MODEL 163.113 /136 /154 /172 /174

## Modification notes

16.3.00	Supersedes STI no. 72.19-011 dated 15.03.00		
---------	---	--	--

P67.30-2038-11

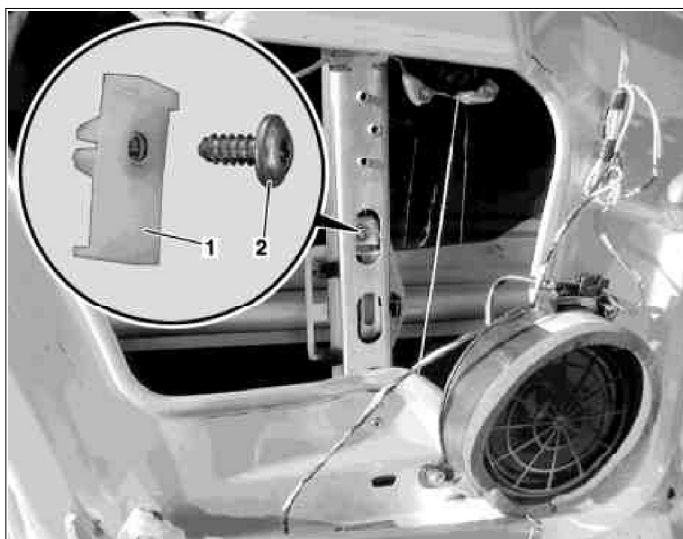
Damage Code	Cause	Remedy	
	Loose window lift mechanism attachment rivets, or failure of the window mounting clip to sufficiently hold window during initial movement.	1 Inspect window lift mechanism attachment rivets and ensure that assembly is securely mounted  <b>i</b> If attachment rivets loose #	
		2.1 Replace attachment rivets	
		3 Inspect window mounting clip (1) and window glass during upward and downward operation  <b>i</b> If movement is detected between window mounting clip (1) and window glass #	
		4.1 Replace window mounting clip (1) AND screw (2)	
		<b>!</b> Apply Loctite® to threads of new screw. <b>i</b> A <b>new</b> window mounting clip and screw should be used whenever repairs are made that require removal of crank window. <b>Nm</b>	*BR00.45-Z-1013-02A  *BA72.12-P-1006-01C
